PLANNING COMMISSION MEETING

LOCATION: TOWNSHIP ANNEX, 7527 HIGHLAND ROAD, WHITE LAKE, MI 48383
THURSDAY, JUNE 20, 2024 – 6:30 PM

Project Name: West Valley
 Description: Final site plan re-approval
 Date on Agenda this packet pertains to: June 20, 2024

RE: West Valley – Final Site Plan and Final Engineering Plan – 9th Review

SHEET 5

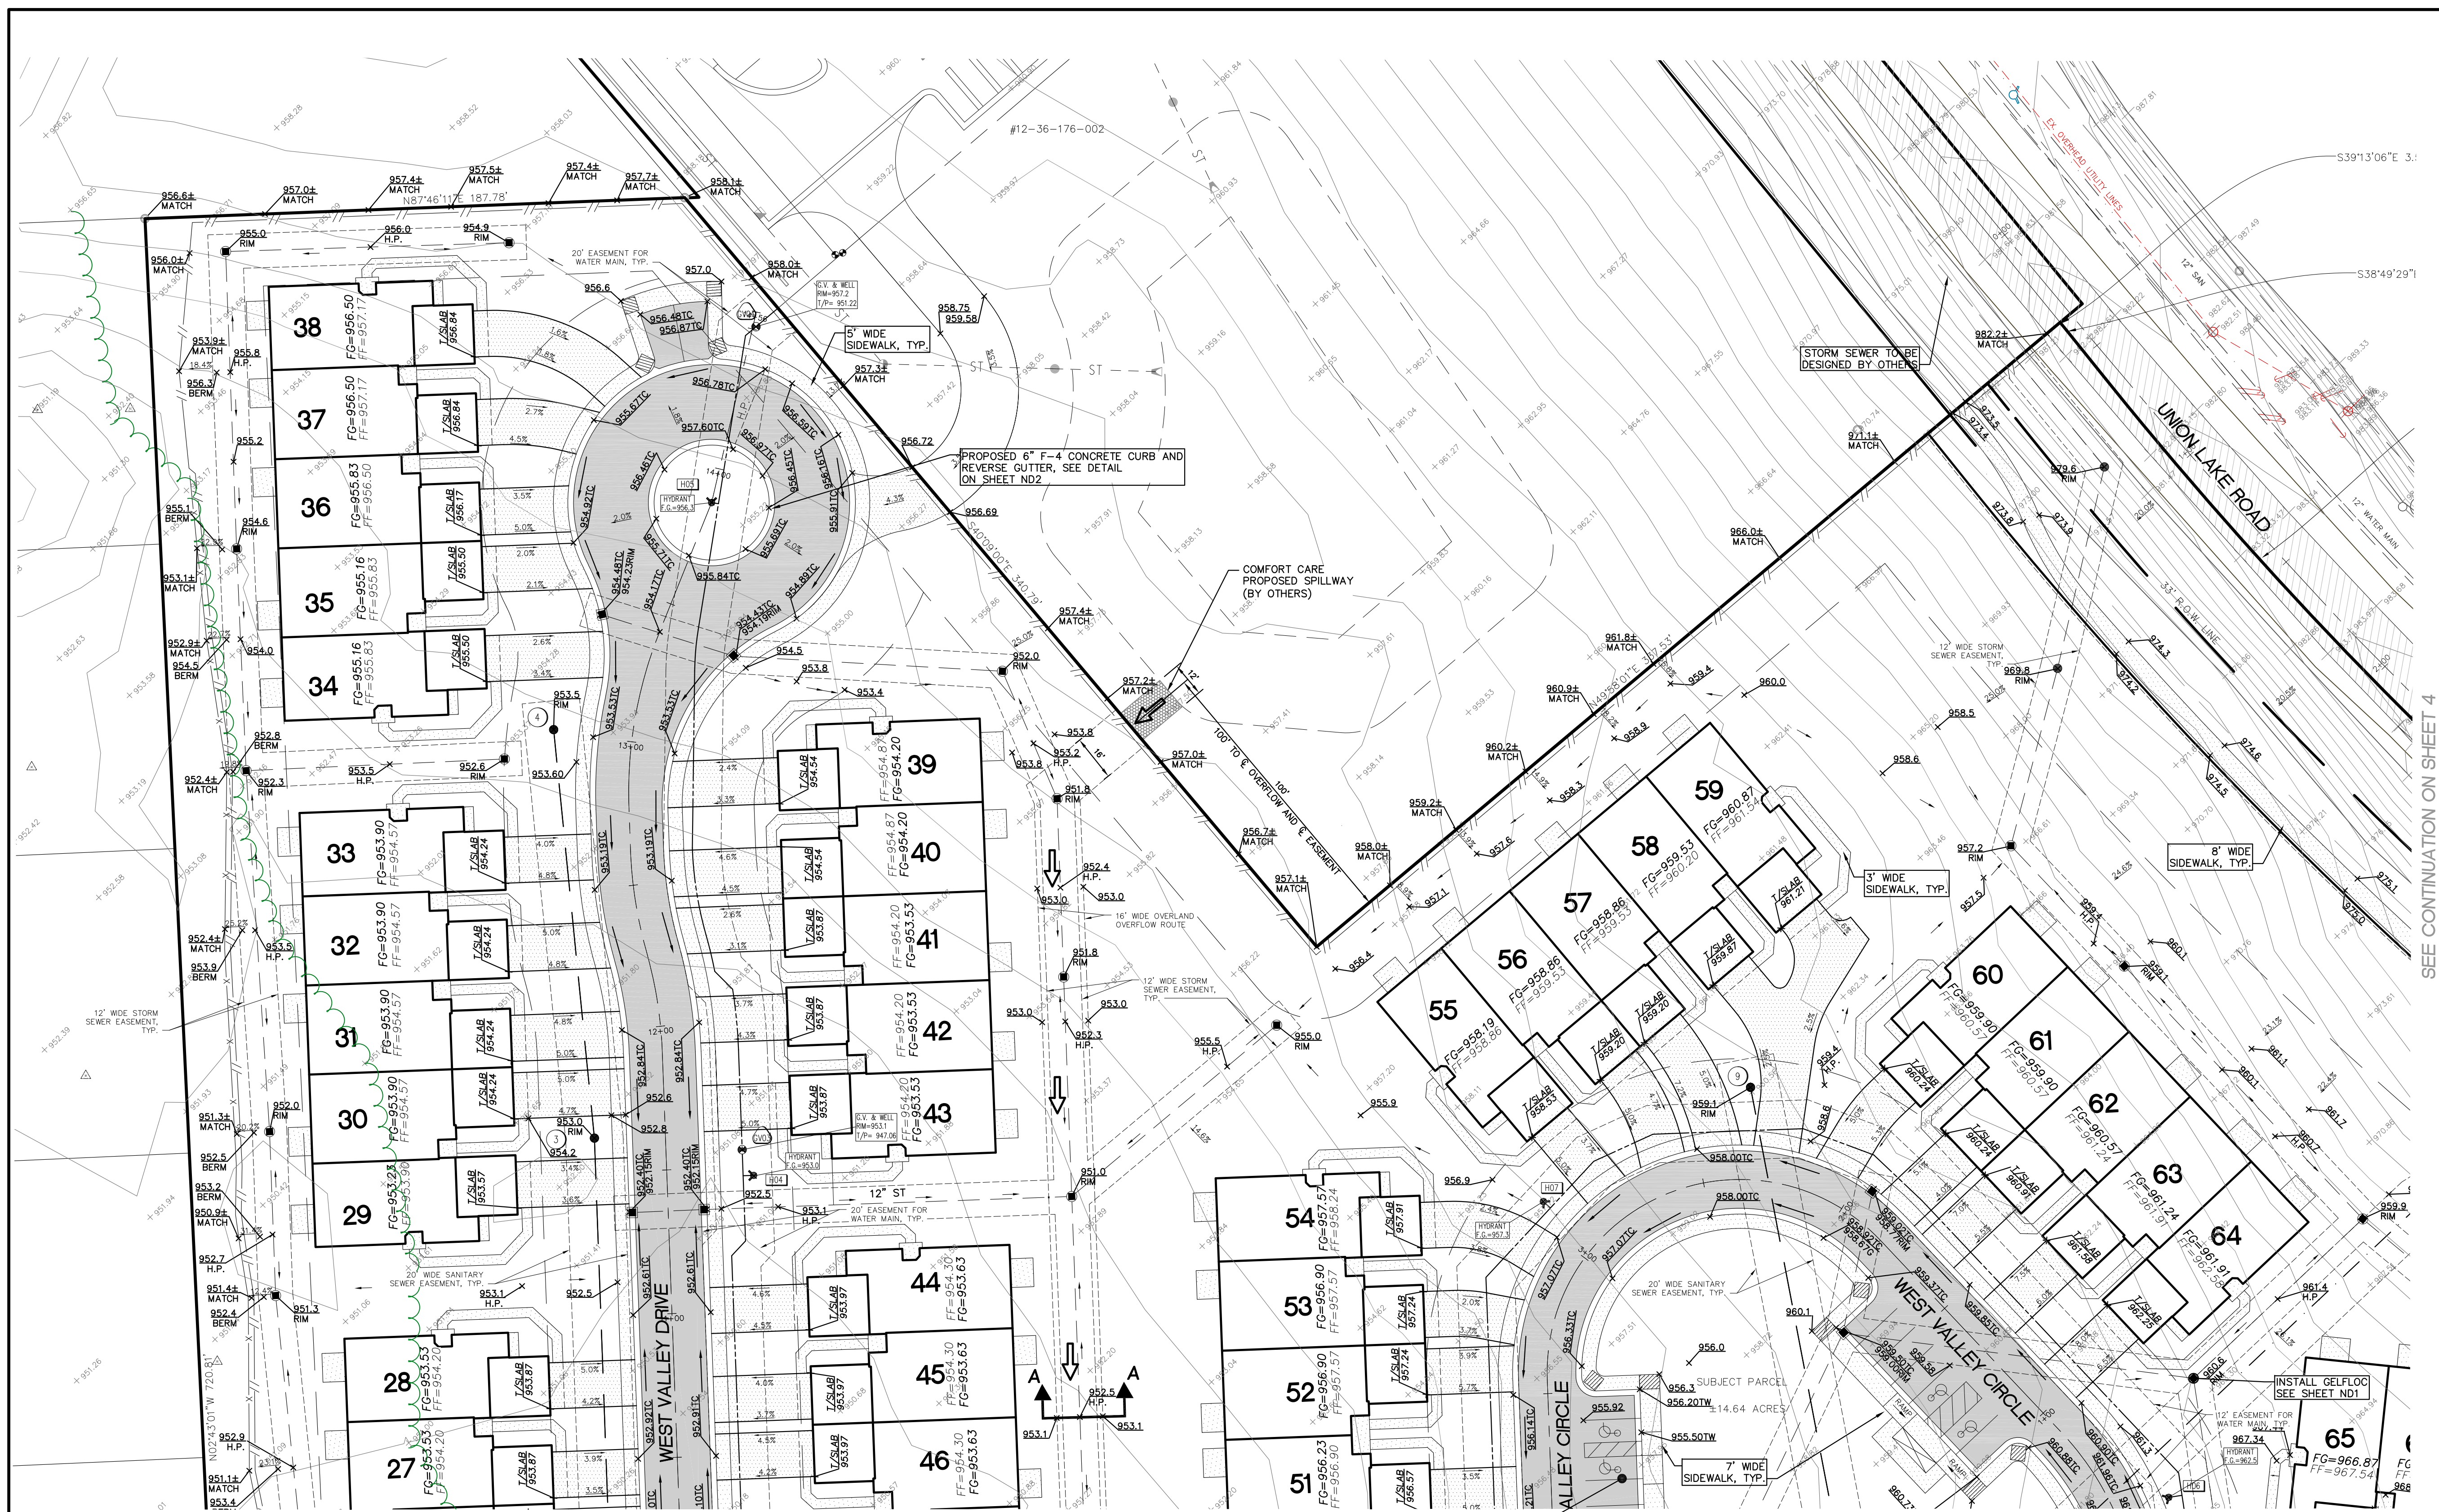
3. *Show the additional off-site drainage path for the overland flow along Casa Loma Drive. Plan Sheet 5 shows this discharge flowing onto casa Loma Drive, but it is not clear where it will go from there. Comment remains outstanding. Although a few additional directional flow arrows have been provided to demonstrate the flow in Casa Loma Drive, please provide and clearly show the flow path down Casa Loma Drive as well as Cedar Island Drive the overland flow shall ultimately go. Comment addressed. Emergency overflow route down Casa Loma Drive is now shown on plan. **Comment remains as a notation.***

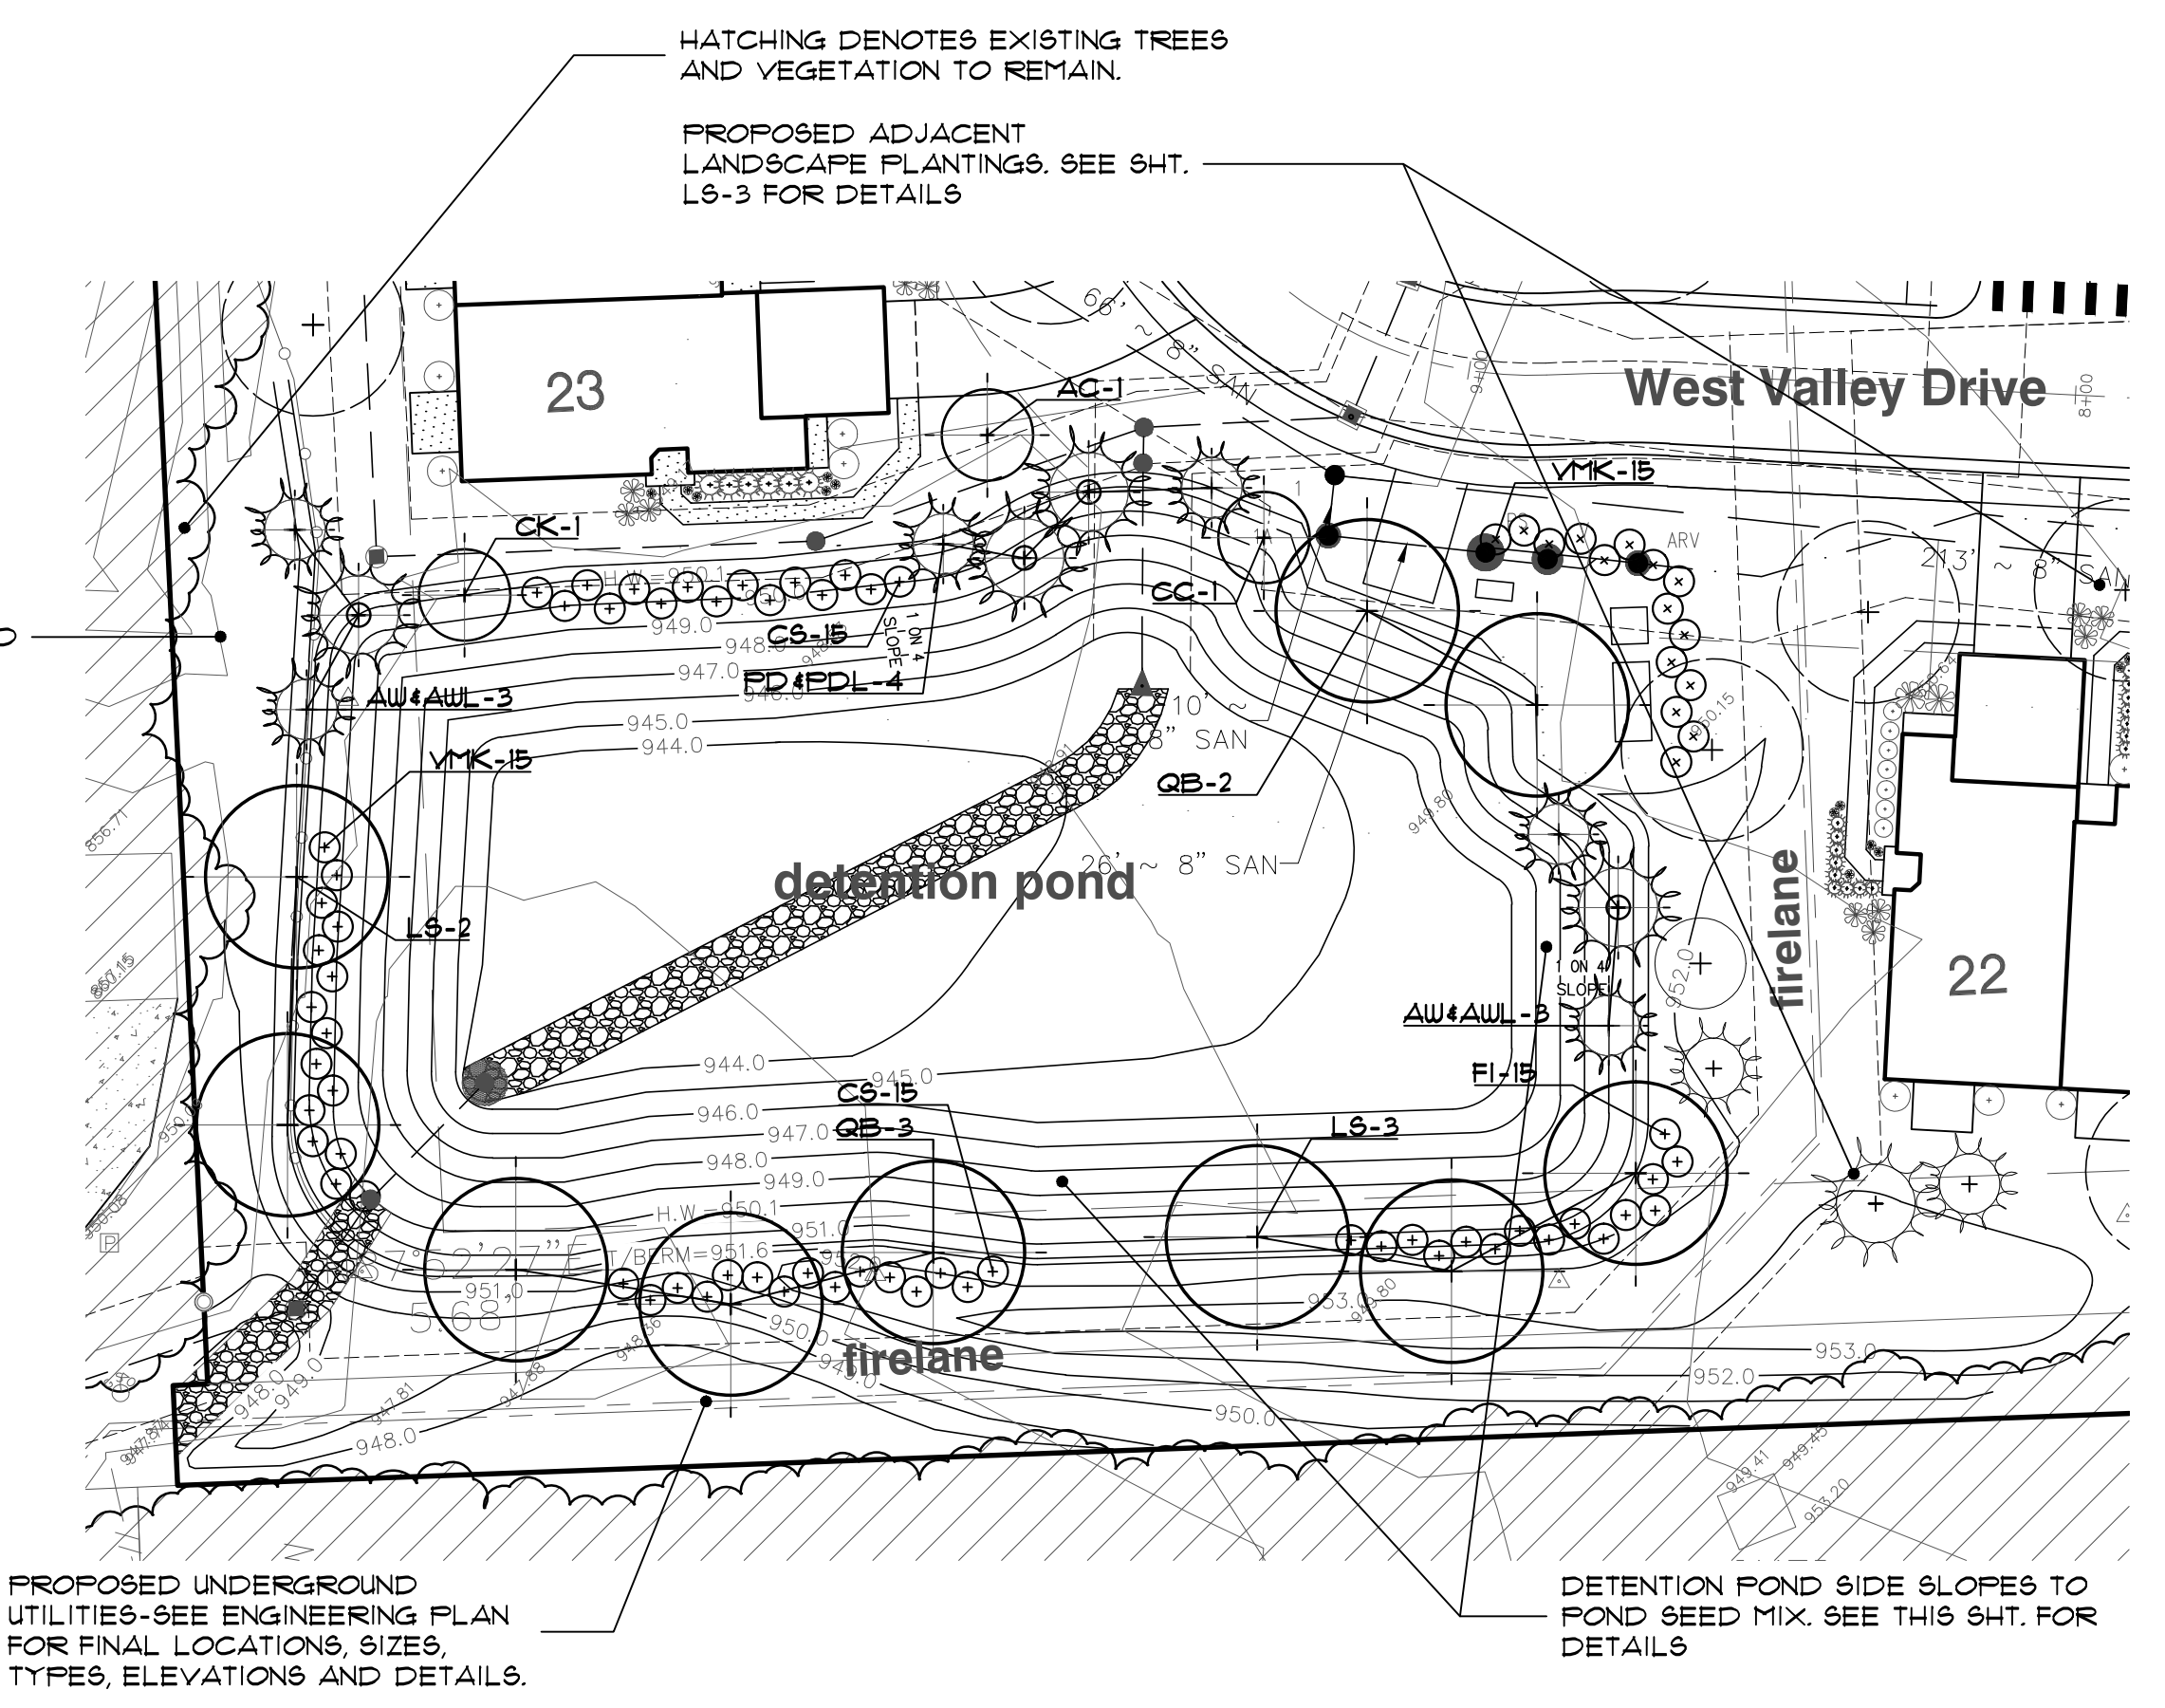
1. Revision dates for Sheets IRR 1 through 6 have been corrected to reflect May 29th, 2024.
2. Sheet LS 5 has a note stating “*All site irrigation systems shall include a rain sensor or similar measure to ensure irrigation down not occur during or shortly after precipitation events.*” It is likely “*down*” is an error and is intended to state “*does*”.
